**ONE - GIRDER - 207G3B (DEV.)**

DATE	09/08	REVISION	ADDED FLG SPLICE TO 56mm FLGS	EEO	DO	9-11-07	
REV. DATE		REMARKS		DWN	CHK	APVL	SHOP
MATERIAL:	AS NOTED	SURFACE PREP. & PAINT:	SEE DWG GNI	HOLES:	12φ	SHOP BOLTS:	NONE
DESCRIPTION:	GIRDER - 207G3B						
STRUCTURE:	RAMP D		BRIDGE NO.	B15N	BRIDGE NO.	BENNINGTON COUNTY	
LOCATION:	VT RTE 279 OVER WALLOOHSAC RIVER		BRIDGE NO.	B15N	BRIDGE NO.	BENNINGTON COUNTY	
PROJ. NO.	AC NH D19-1K51		JOB NO.	408-2		DWG NO.	207
CUSTOMER:	KUBRICKY CONSTRUCTION		DATE:	07/13		DATE:	08/17
							REV. △

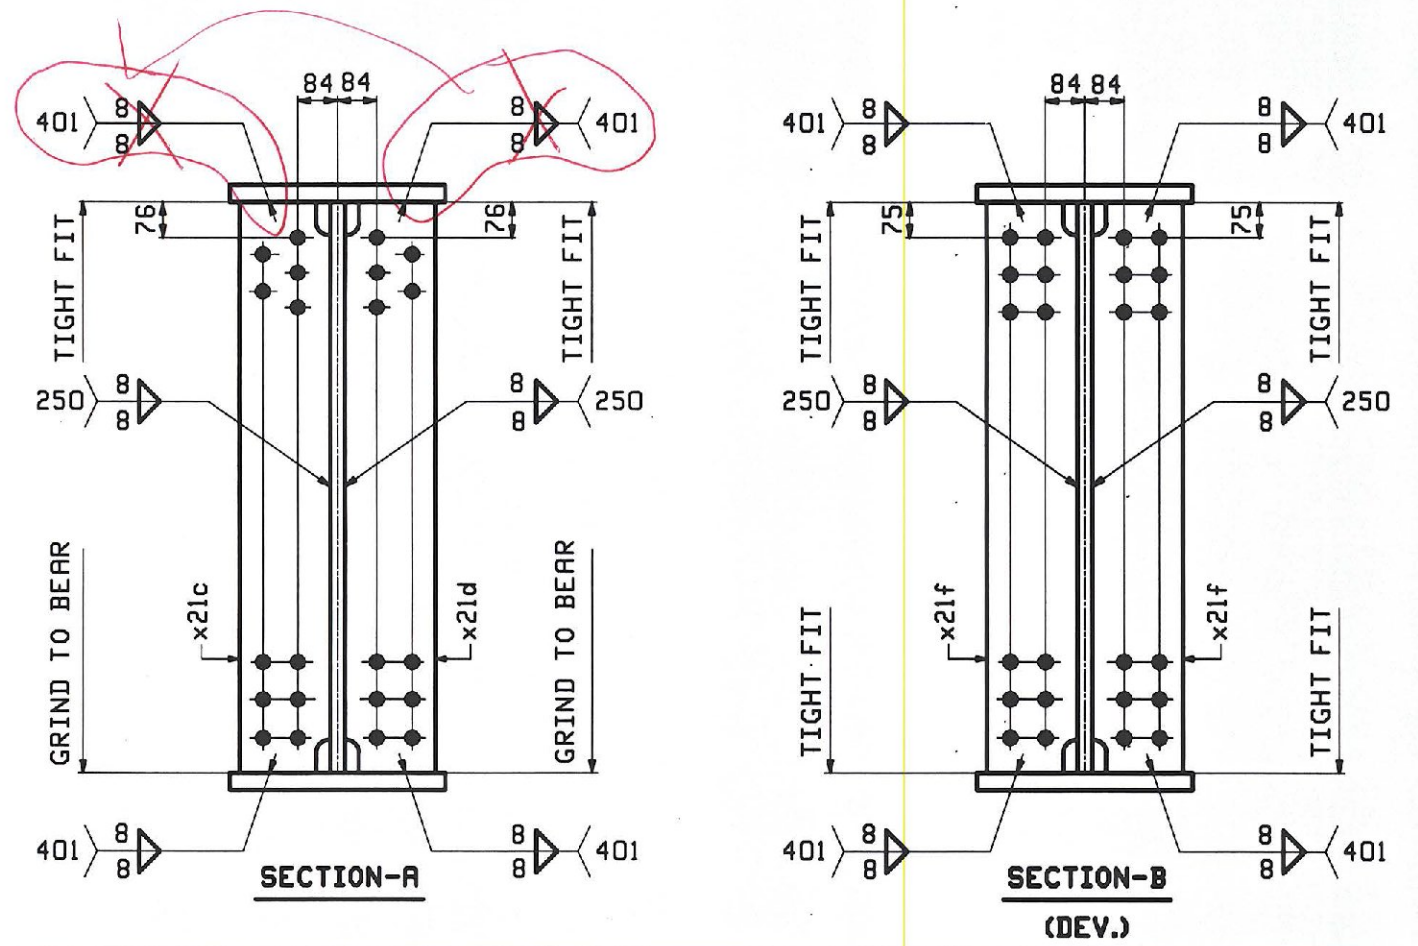
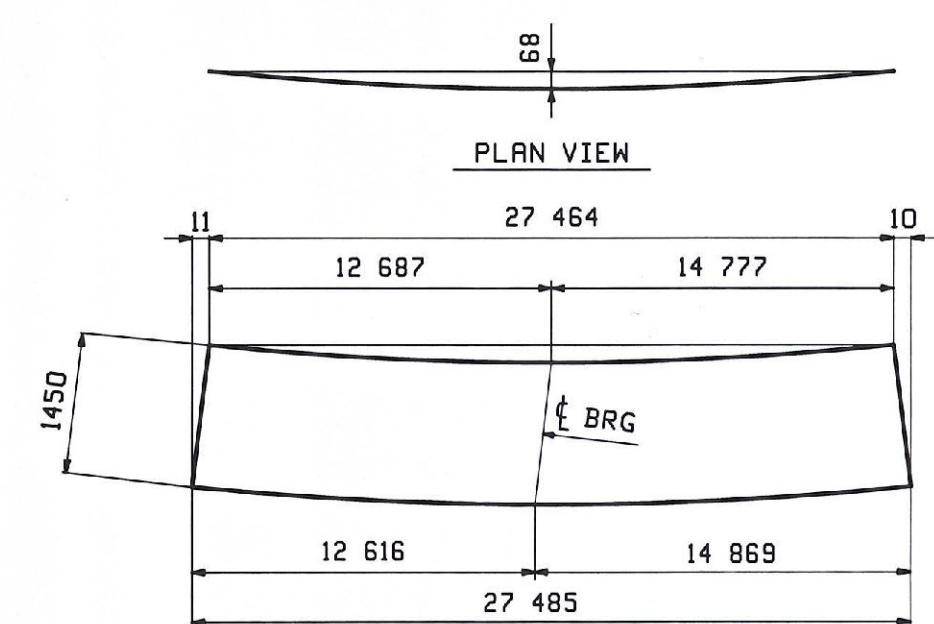
NO WELD BETWEEN TOP FLANGE AND STIFFENERS AT THE PILES. TIGHT FIT ONLY
